Access Compliance Report

Public Rights-of-Way

| Intersection ID: 50708 | Main Street: CELEBRATION_RD | Cross Street: BROTHERLY_LN | Location: NW |
| ADA ID: 680A952D8ACE | Ramp Type: PerpDiag | Initial Pass/Fail: Fail | Overall Compliance: No |

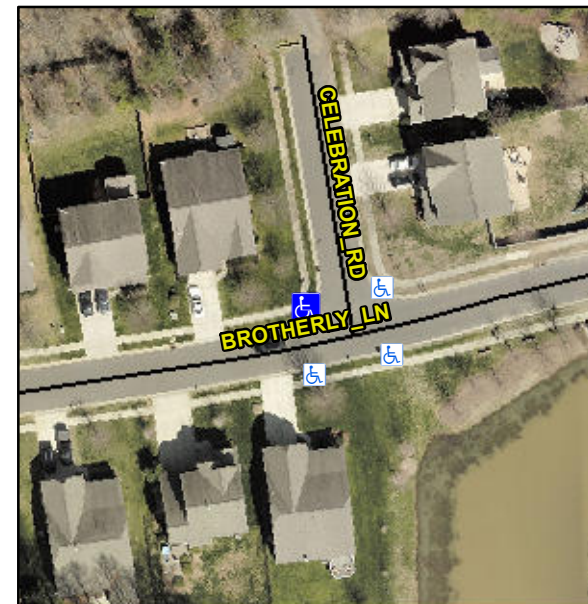
R304.5.3

| Compliance | Description | Data | Compliance | Description | Data |
|------------|-----------------------|------|------------|-----------------------------|------|
| Yes | Ramp Width (in) | 48.0 | No | Ramp XSlope (%) | 5.6 |

Remove & Replace Curb Ramp With Two New Directional Ramps or Equivalent.
